SERIAL: BSEP 01-0041

BRUNSWICK STEAM ELECTRIC PLANT, UNIT NOS. 1 AND 2  
DOCKET NOS. 50-325 AND 50-324/LICENSE NOS. DPR-71 AND DPR-62  
REVISIONS TO PLANT EMERGENCY PROCEDURES

#### Summary of Revisions

ATTACHMENT 6  
Page 1 of 1  
**Control Room Emergency Communicator Flow Chart**

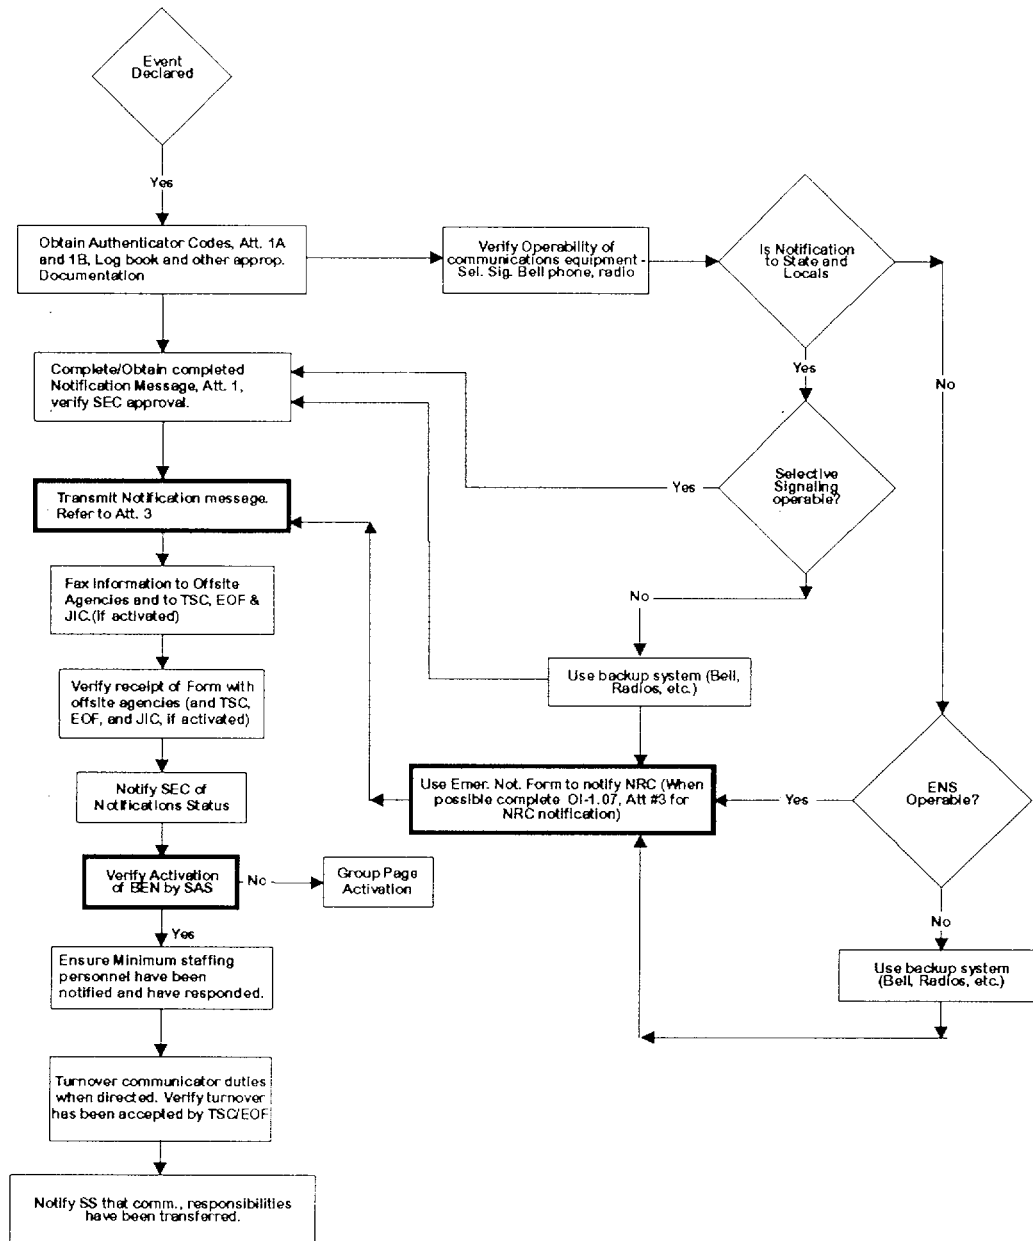
5. Removed a reference to FTS-2000 telephones in Attachment 3 to reflect changes to the Emergency Telecommunications System;
  6. Revised Attachment 6, "Control Room Emergency Communicator Flow Chart," to correct the flow chart processes; and

ATTACHMENT 2  
Page 1 of 1  
Emergency Operations Facility (EOF) Recommended Layout  
Room 122/123

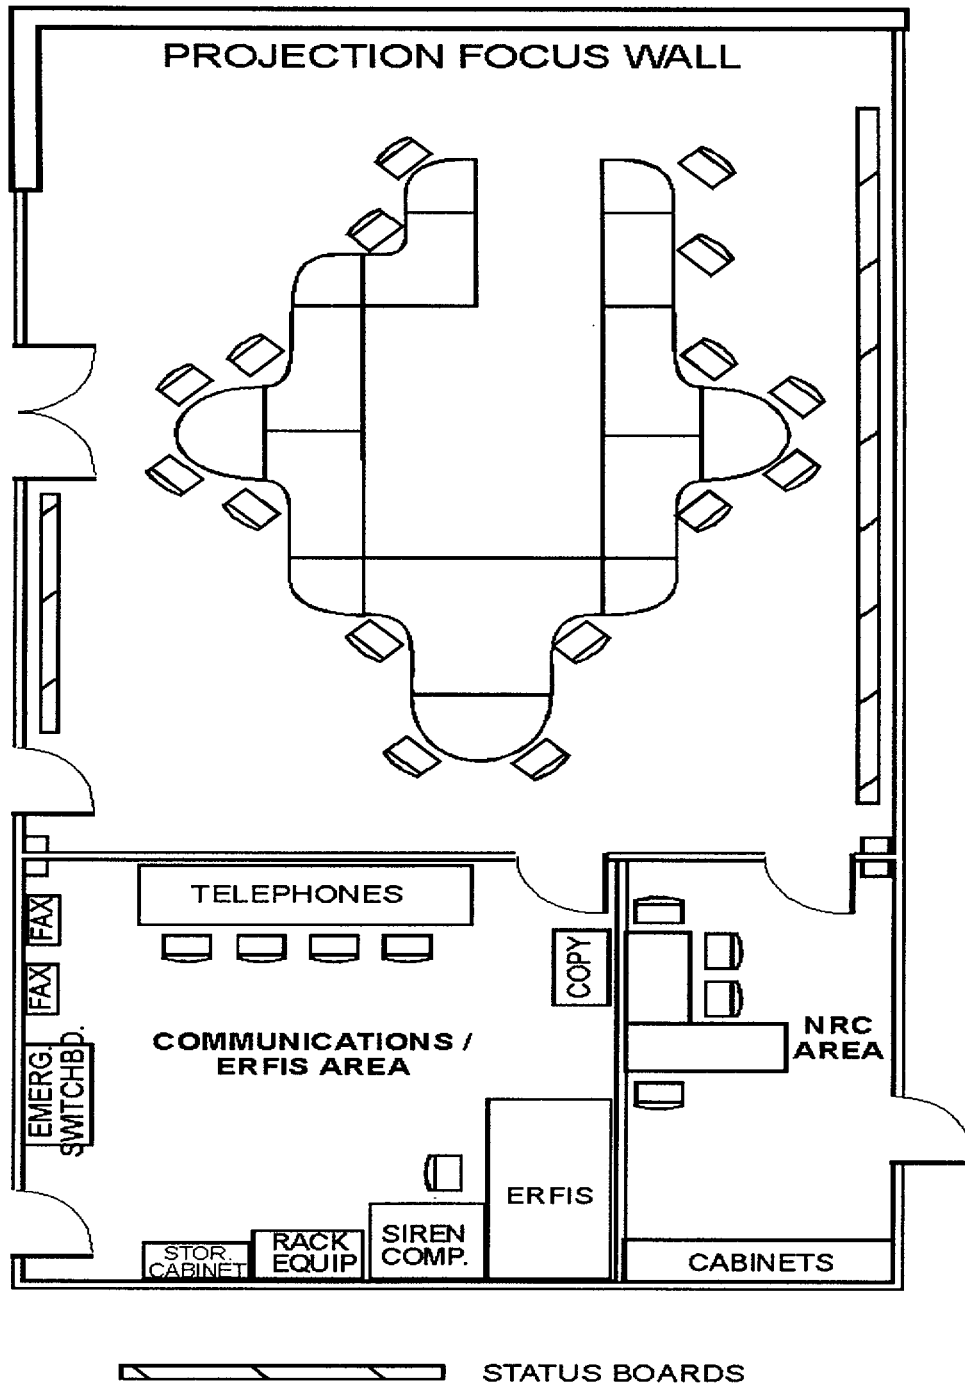
4. Revised Section 5.14.8 to provide additional guidance for the HPN Communicator when making NRC notifications;
  5. Revised Attachments 2, 3, 4, and 5 to reflect changes in the EOF layout; and
